URGENT MEDICAL DEVICE CORRECTION

Increased Potential for Reduced Energy or No Energy Delivered During High Voltage Therapy When Programmed AX>B

Devices Include the Following Models:

May 2023

Example screen illustrating reduced-energy shocks for an Evera XT DR device.

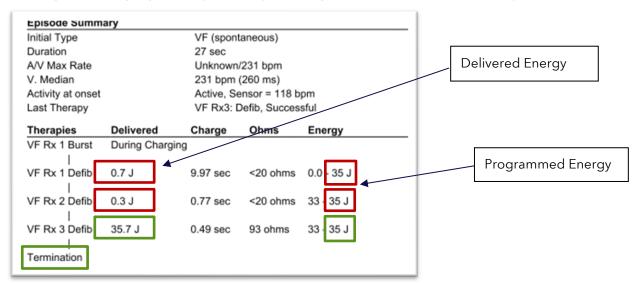
- Verify delivered energy is consistent with programmed energy in the Episode Summary.
 Note: The image below highlights an episode experiencing intermittent reduced HV therapies (red boxes).
